Outer Dowsing Offshore Wind

Outer Dowsing Noise Abatement Systems Commitment Clarification Note

Document Reference: 27.6

Figure 1 Predicted SEL contours at 5 dB increments for a single monopile installation, with and without NAS, in relation to the Southern North Sea SAC

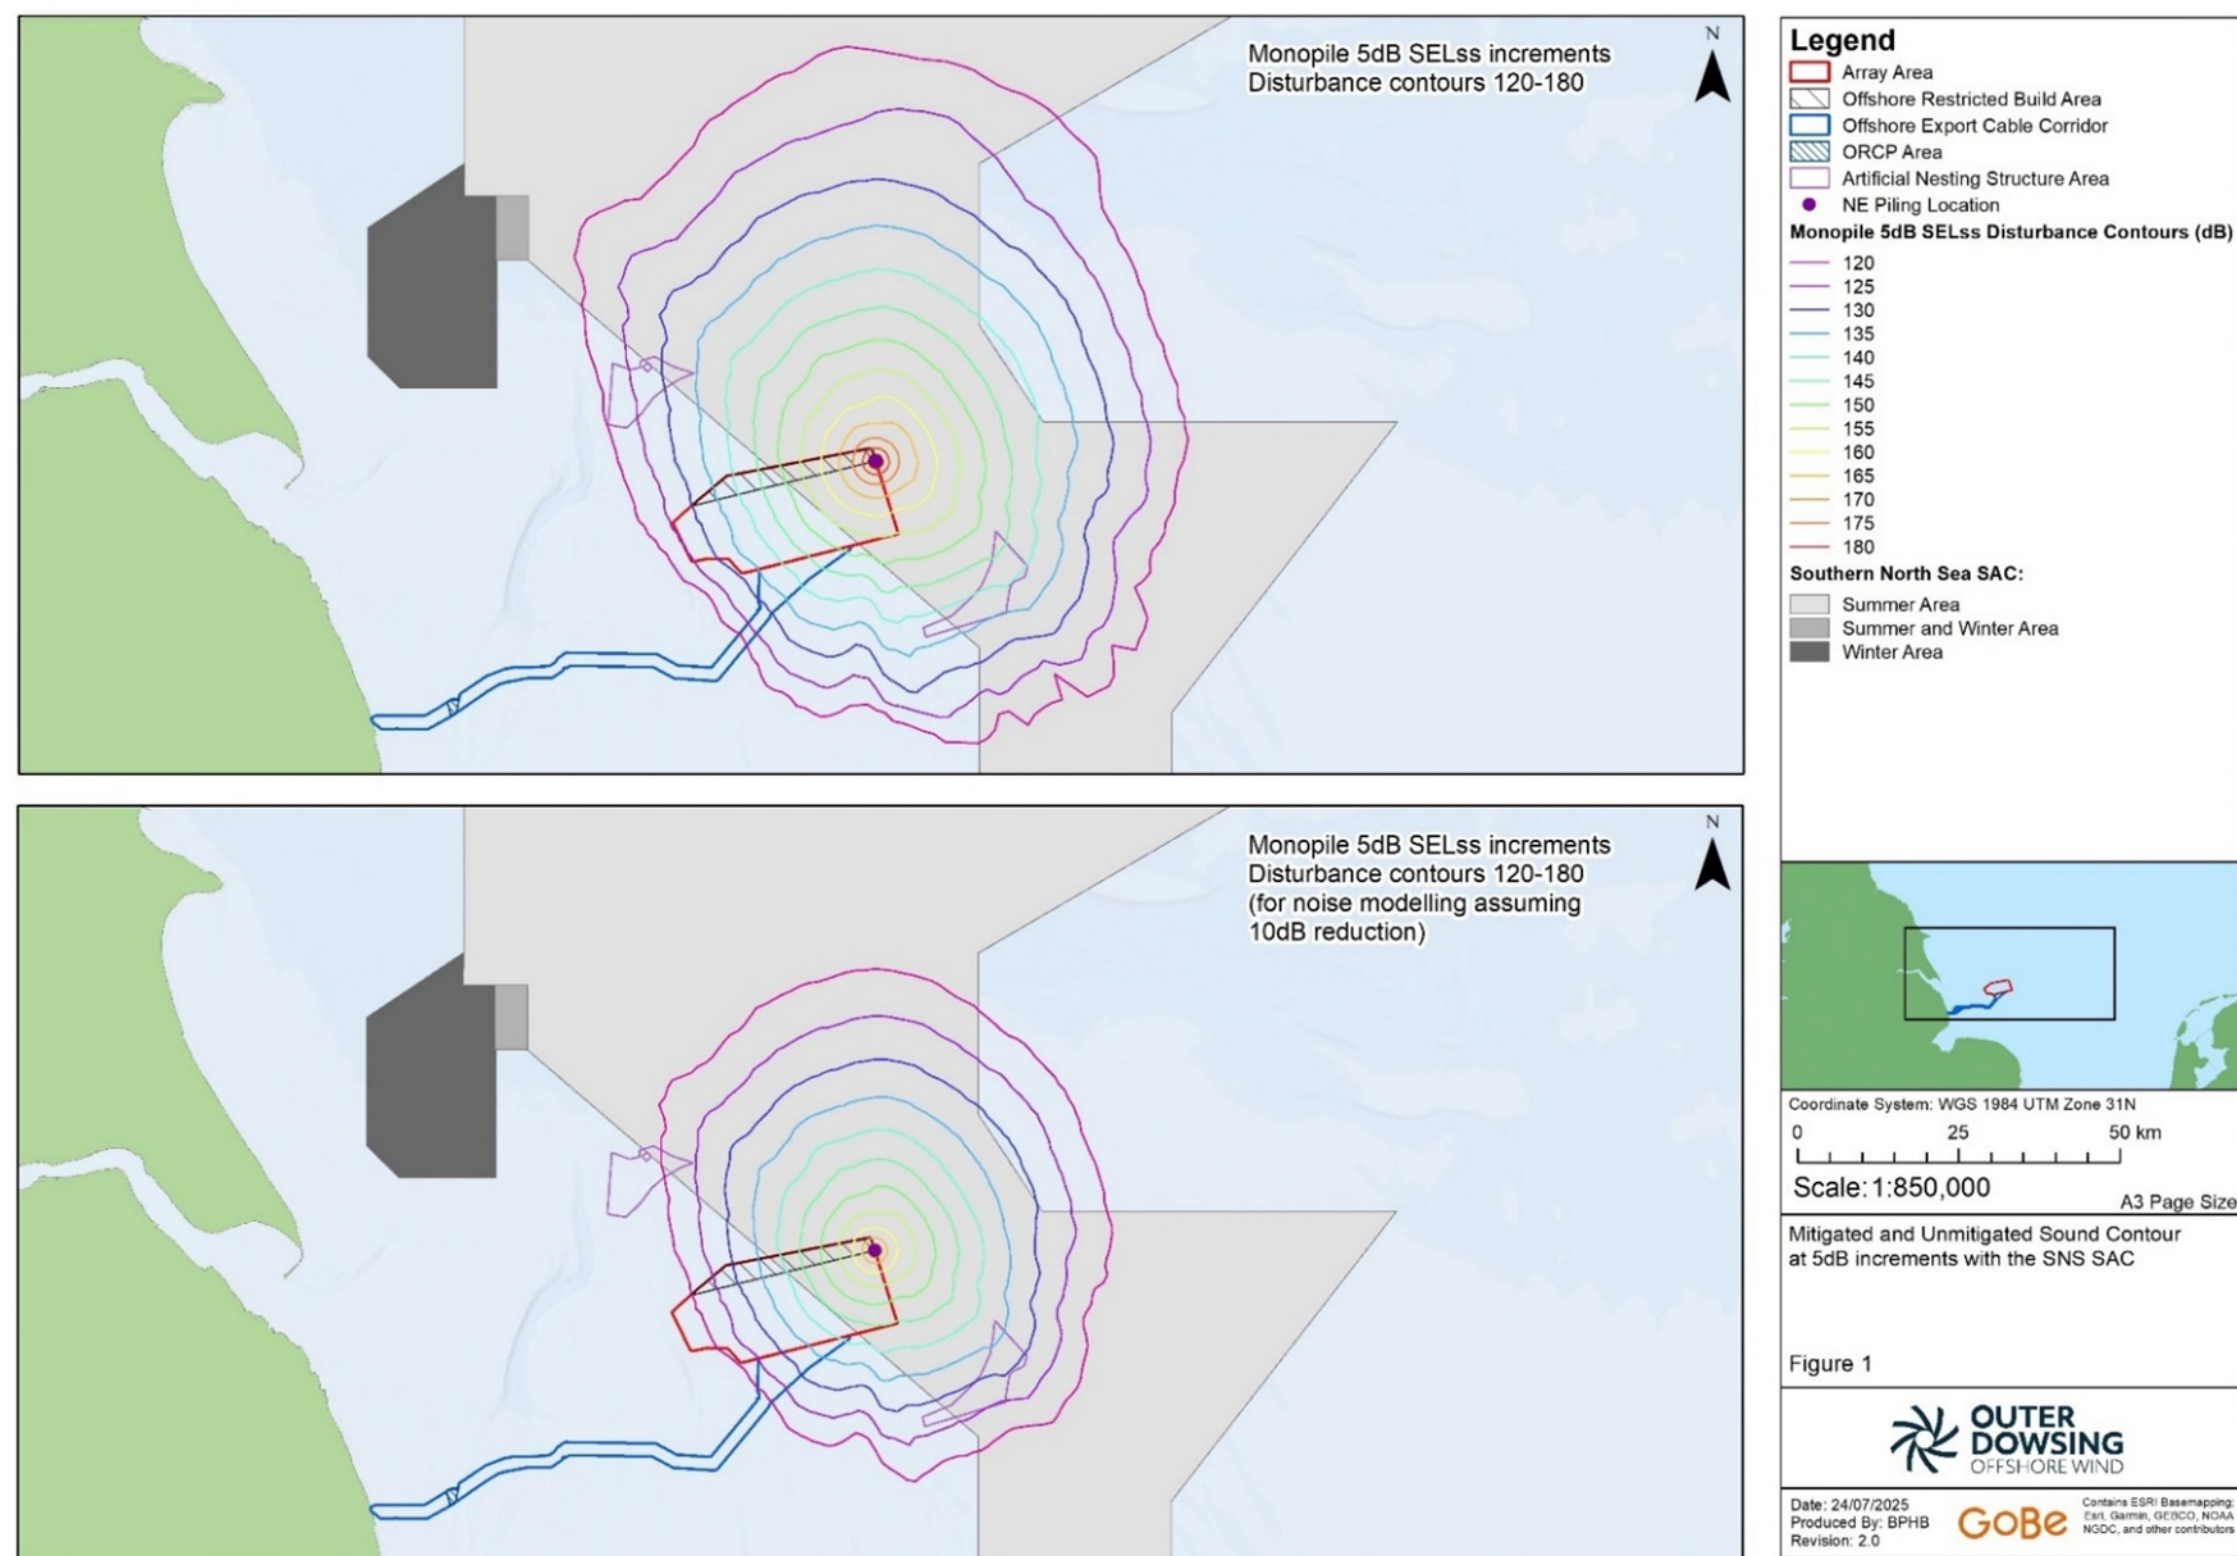
35. In Appendix J6 Natural England's Risk and Issue Log Deadline 6 (REP6-153) Point 18 in Tab E Marine Mammals and Appendix E4 Natural England's Advice on Marine Mammals (REP6-148), Natural England stated they did not agree with the Applicant's conclusion of no Adverse Effect on Integrity (AEol) for the Southern North Sea SAC and advised that the Applicant should commit to mitigation measures such as NAS.

40. To support this position, Figure 1 presents the predicted sound exposure levels (SEL) contours for a single monopile installation at the NE modelled location, overlaid with the Southern North Sea SAC. The NE modelled location is considered the worst case as it results in the greatest overlap with the Southern North Sea. The figure compares unmitigated and mitigated scenarios, with the mitigated scenario assuming a 10 dB reduction in source levels. Under the mitigated scenario, there is a marked reduction in the spatial extent of SEL disturbance contours, indicating that a smaller area of the SAC would be exposed to elevated noise levels.

41. This reduction in the predicted extent of noise exposure highlights the benefit of NAS in reducing the area of the SAC subjected to elevated sound levels, and would also lead to a reduction in the number of harbour porpoise predicted to be disturbed, thereby reducing the Project's contribution to cumulative disturbance of harbour porpoise. The noise contours presented in Figure 1 therefore supports the Applicant's position that the use of NAS would minimise the risk of disturbance to harbour porpoise, reinforcing the conclusion of no AEoI from Project alone on the Southern North Sea SAC.

Figure 3 Predicted SEL contours at 5 dB increments for a single monopile installation at ORCP South location, with and without NAS, in relation to the Wash and North Norfolk Coast SAC

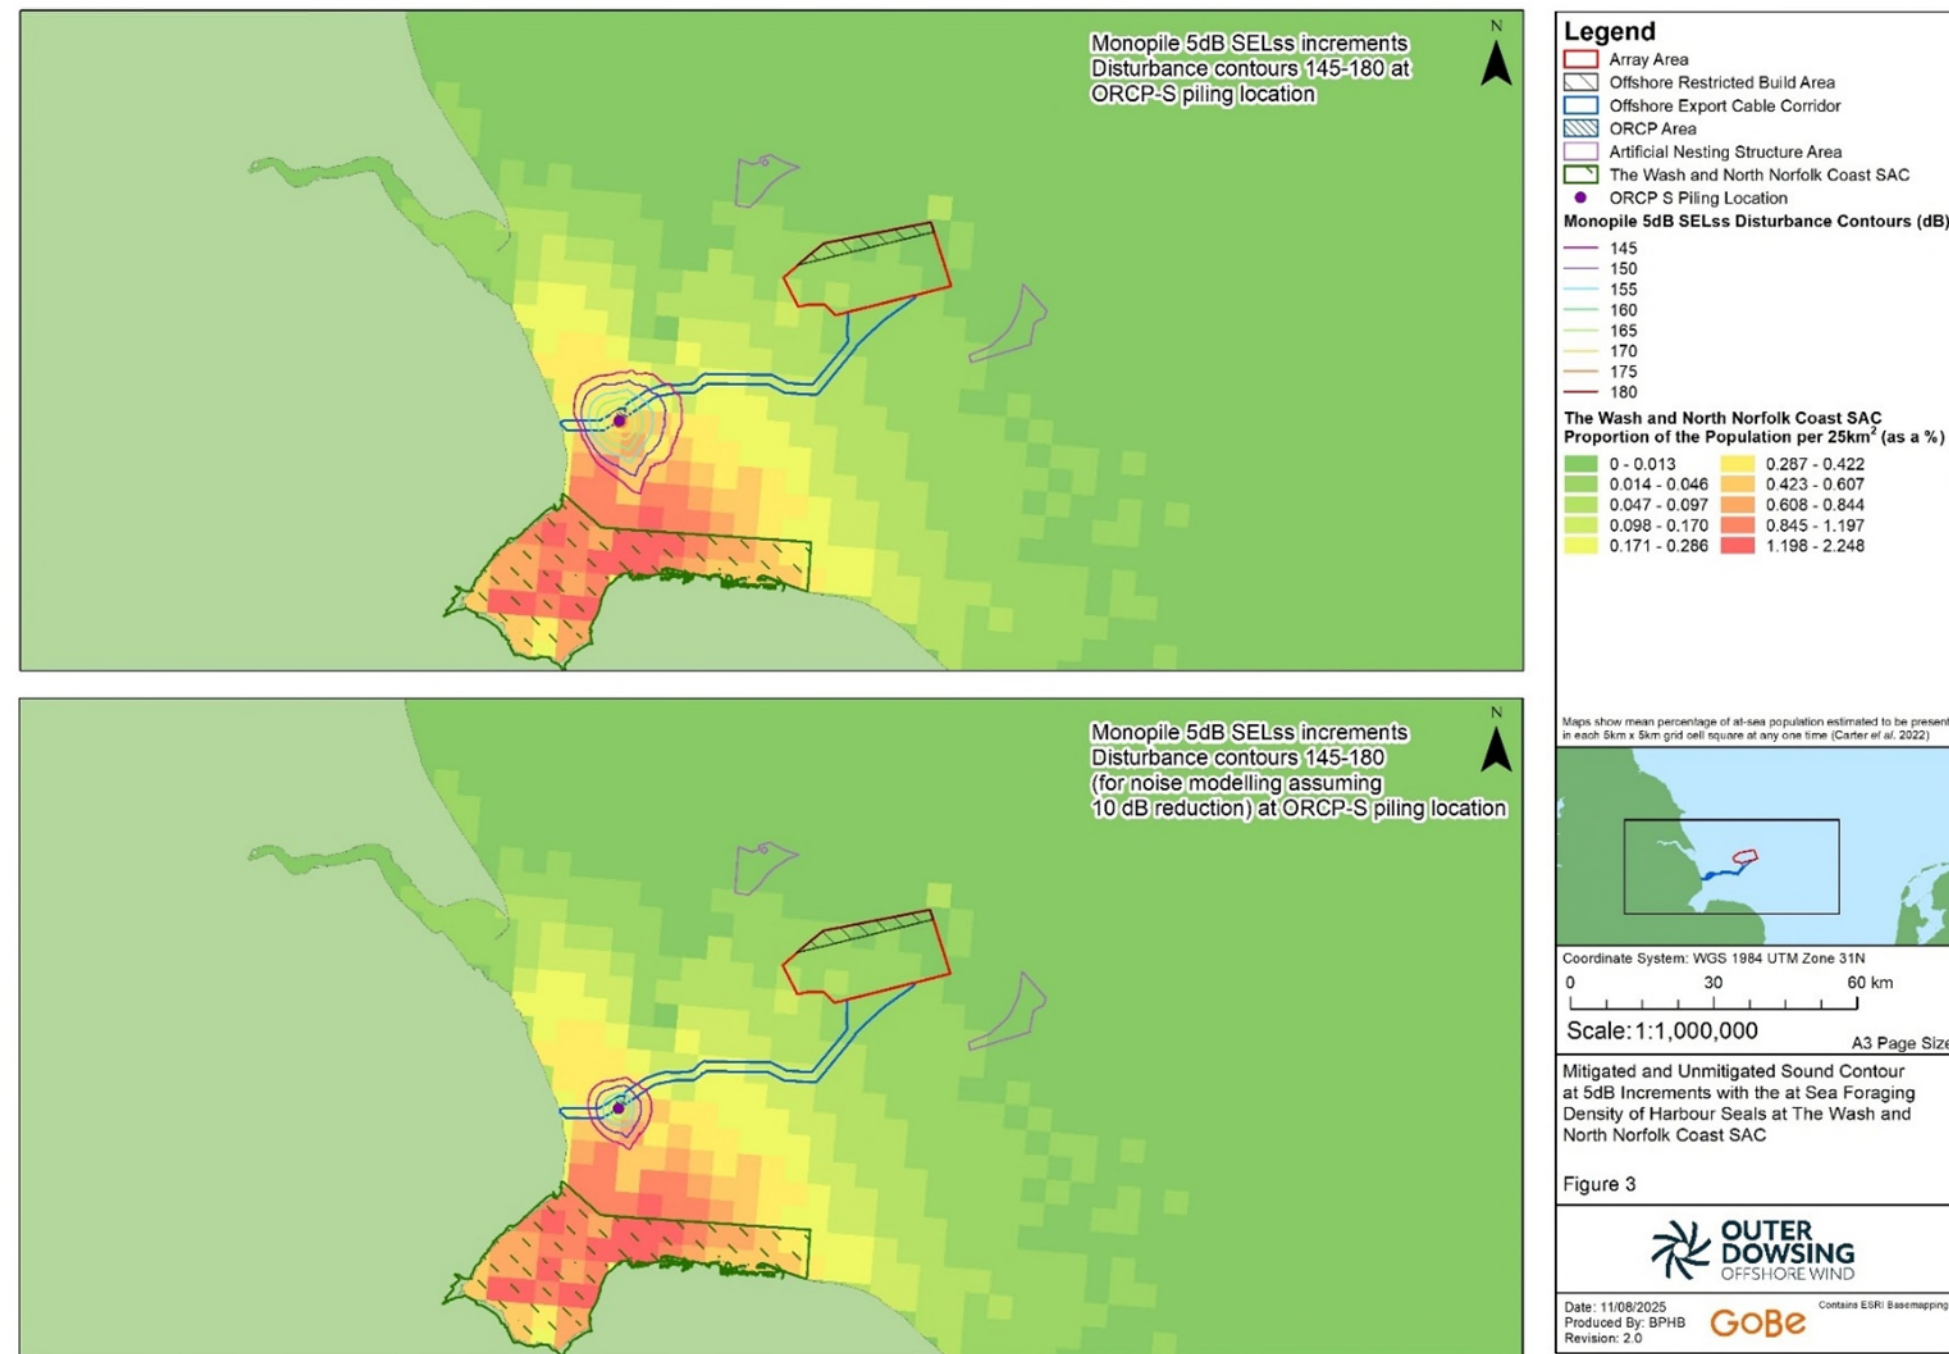
"Natural England cannot agree to the conclusion of no AEol on harbour seals because of the high proportion of animals expected to be disturbed by underwater noise caused by piling from the project in combination with other projects ... To reduce the disturbance to harbour seals, the Applicant should commit to noise abatement or noise reducing technology. This commitment would resolve issues associated with harbour seal disturbance from underwater noise caused by piling".

63. To support this position, Figure 3 presents predicted SEL contours for a single monopile installation at the worst-case location the ORCP, overlaid with harbour seal at-sea density data associated with The Wash and North Norfolk Coast SAC (from Carter *et al.*, 2022). The ORCP location is considered the worst-case location due to proximity to the Wash and North Norfolk SAC and the number of individuals disturbed. The figure compares unmitigated and mitigated scenarios, with the latter assuming a 10 dB reduction in source levels in line with the Applicant's commitment to NAS. Under the unmitigated scenario, the predicted SEL contours cover a larger area, extend closer to the SAC boundary, and overlap with more area of higher harbour seal density. In contrast, the mitigated scenario shows a reduction in the spatial extent of the SEL contours, greater distance from the SAC boundary to the outermost noise contours, and overlap with less area of higher harbour seal density. When the reduced disturbance contours for mitigated piling are considered in the dose-response function, up to 8 harbour seals are predicted to be disturbed, which is a reduction when compared to the unmitigated scenario of 154 individuals presented in Table 11-65 of Chapter 11: Marine Mammals (REP6-020). The reduction in impact would apply to all piling locations within the Project area as a result of reduced area of disturbance when assuming a 10 dB reduction in source levels.

65. The reduction in the predicted extent of noise exposure under the mitigated scenario highlights the benefit of NAS in reducing the disturbance impact to the harbour seal feature within and outwith the SAC. The noise contours presented in Figure 3 therefore supports the Applicant's position that the commitment to NAS helps to reduce the risk of disturbance and reinforces the conclusion of no AEoI from the Project alone on The Wash and North Norfolk Coast SAC.
